# **TRAVIS COUNTY ESD #4 FIRE STATION PARKING LOT IMPROVEMENTS**

**4200 CITY PARK RD  
SP-2020-0255DS**

# FOUR VARIANCE REQUESTS

# VARIANCE REQUEST 1

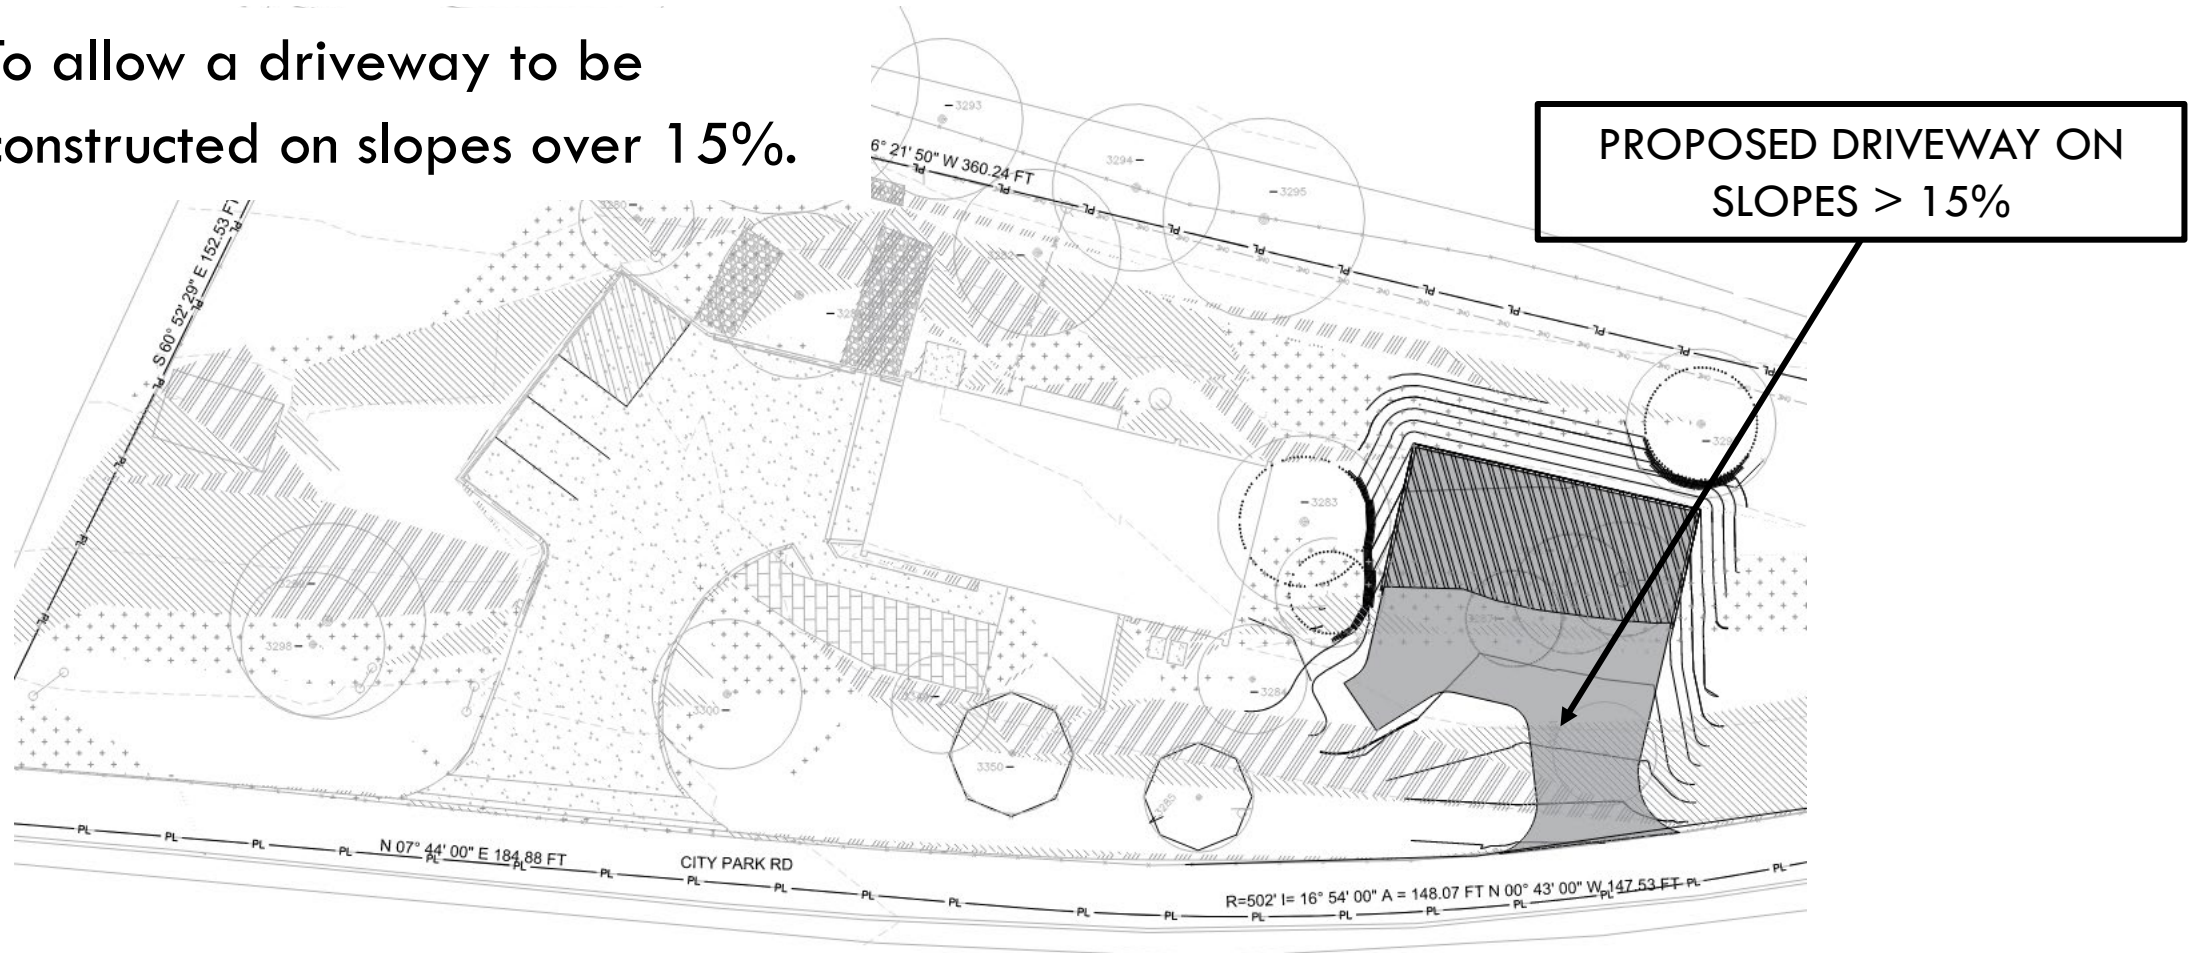
To allow a driveway to be constructed on slopes over 15%.

1. Driveway construction on slopes over 15%;
2. Parking lot construction on slopes over 15%; and
3. Fill over 4 feet.

# VARIANCE REQUEST 2

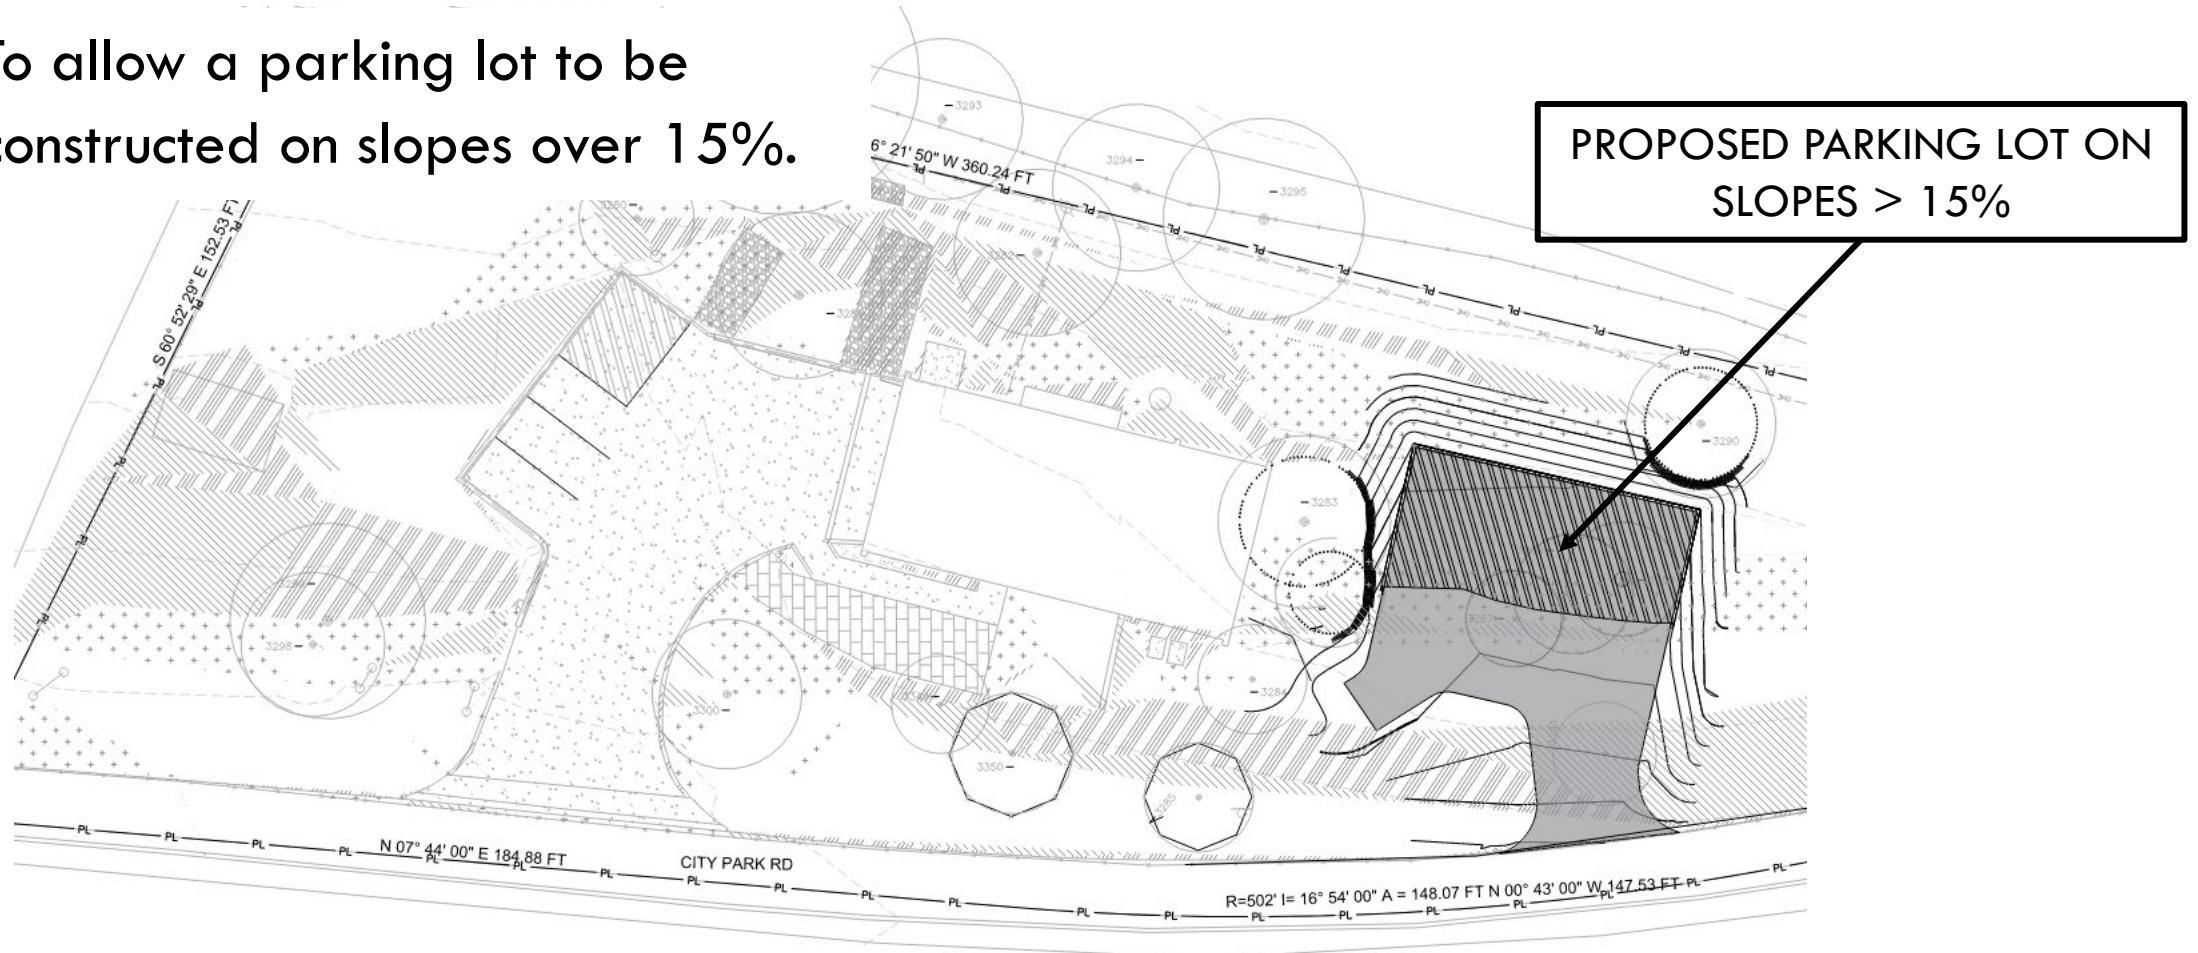
To allow a parking lot to be constructed on slopes over 15%.

# VARIANCE REQUEST 3

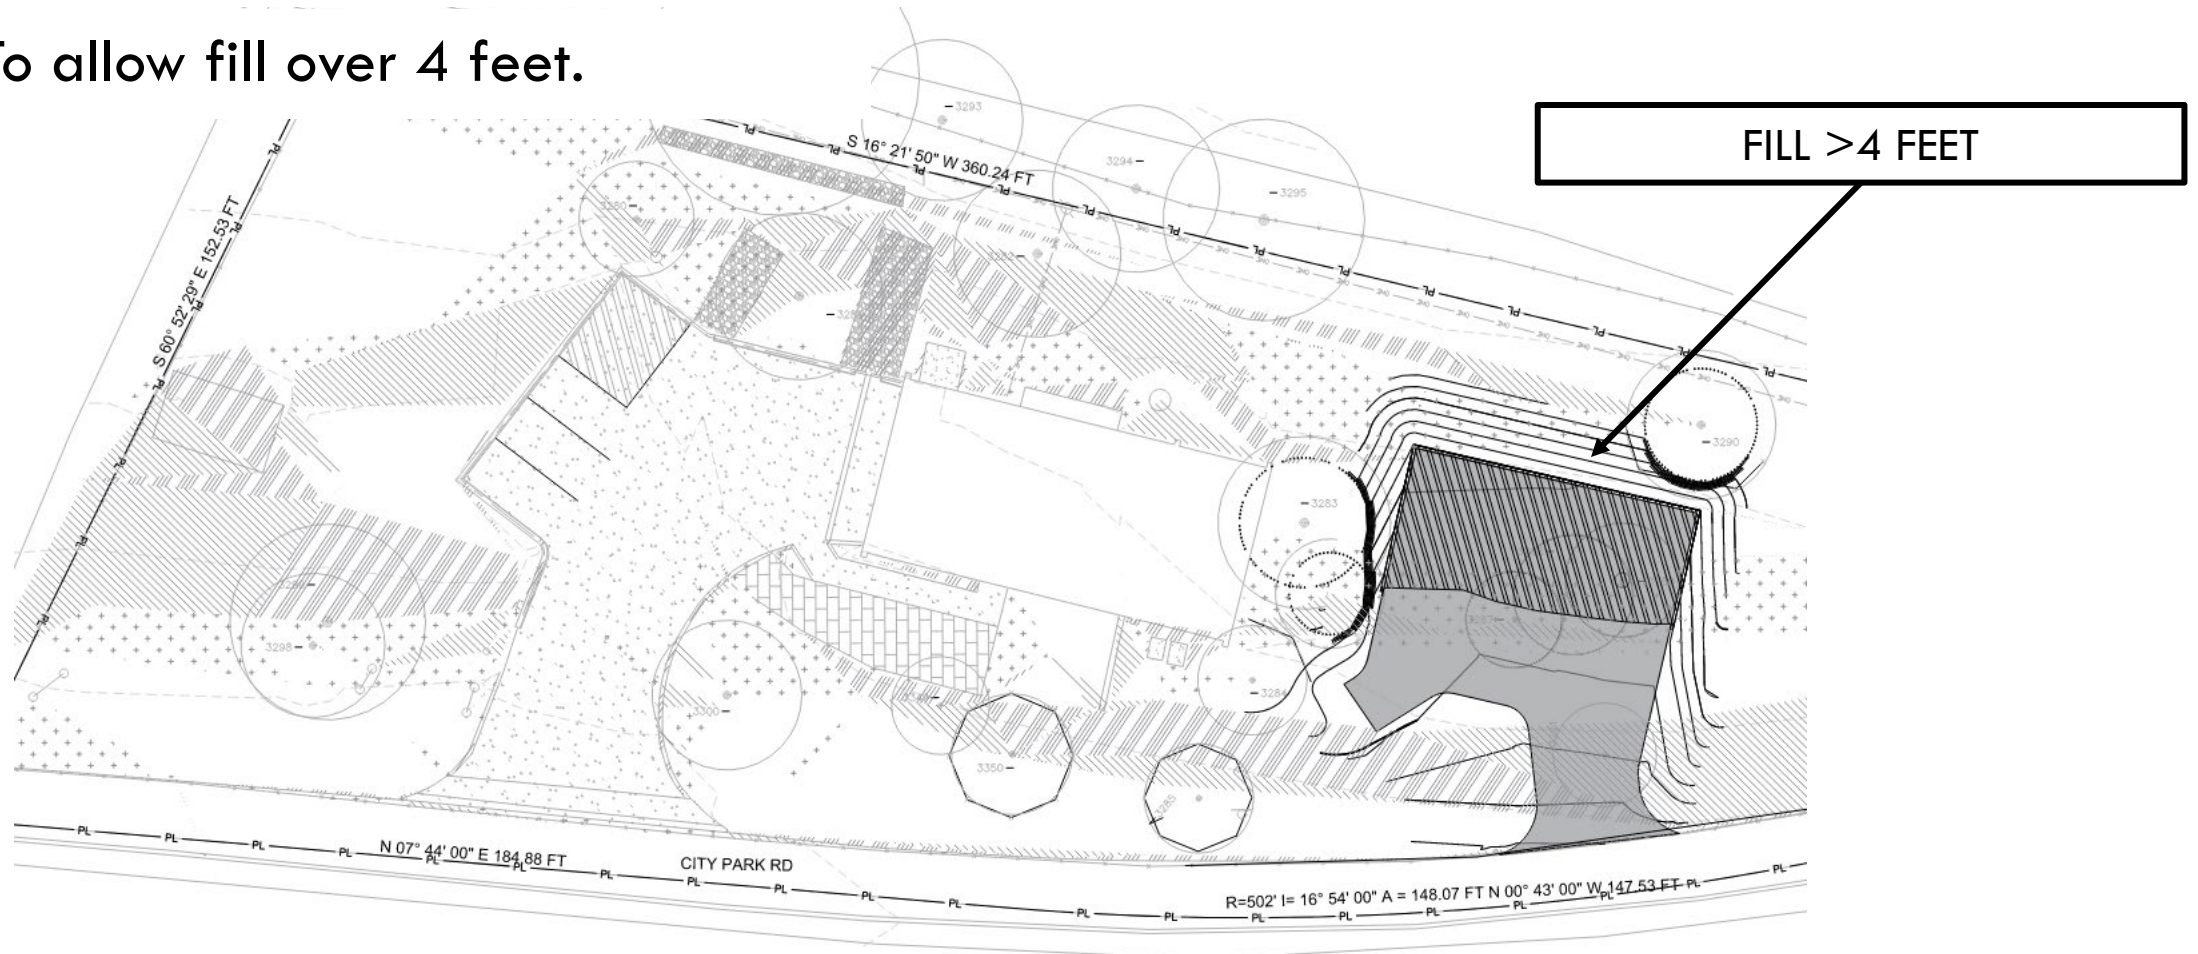
To allow fill over 4 feet.

1. The applicant will provide vegetative filter strips downslope of the development that will provide a diffuse flow to avoid creating downslope erosion.
2. The applicant will provide structural fill to contain the fill during construction (i.e., structural containment of the fill over 4 feet).
3. The applicant will decompact and revegetate the areas adjacent to the ROW that have been used for parking.
4. The site will provide a 40% downstream natural area to treat runoff from impervious cover.

# VARIANCE REQUEST 4

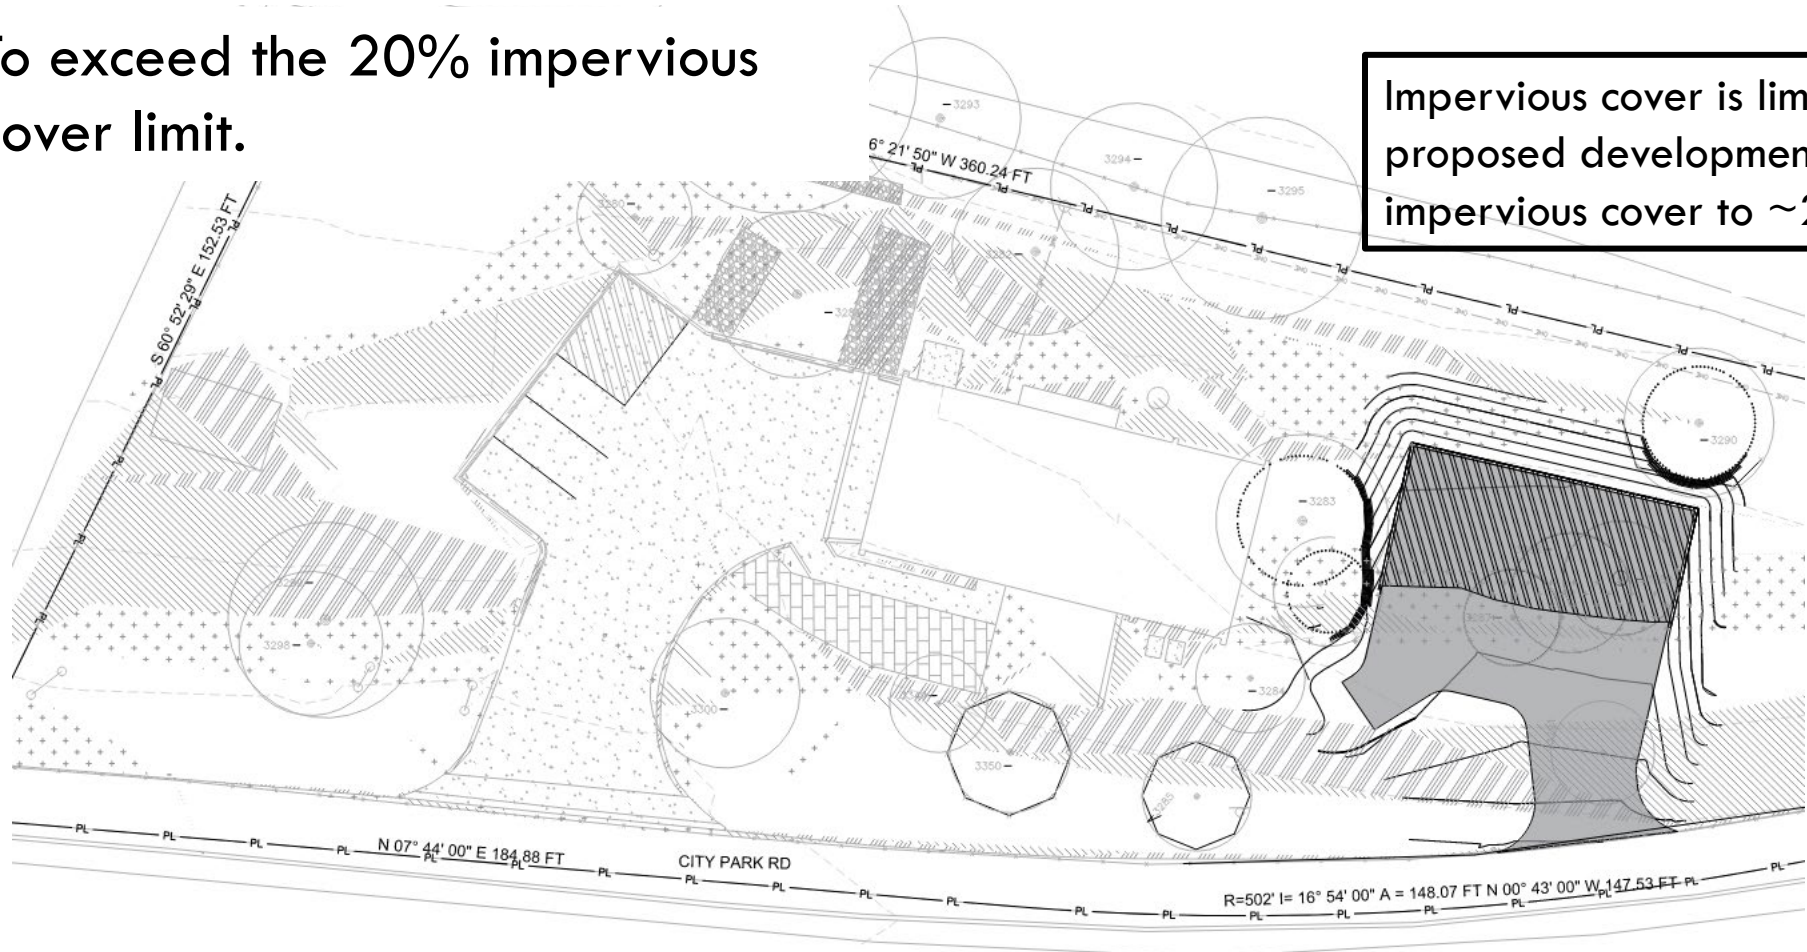
To exceed the 20% impervious cover limit.

Impervious cover is limited to 20%. The proposed development would increase impervious cover to ~27.5%.

Staff cannot recommend the impervious cover variance because the following findings of fact cannot be addressed:

- 1 – The variance creates a significant probability of harmful environmental consequences.
- 2 – Development with the variance reduces water quality below the water quality that would be achievable without the variance.
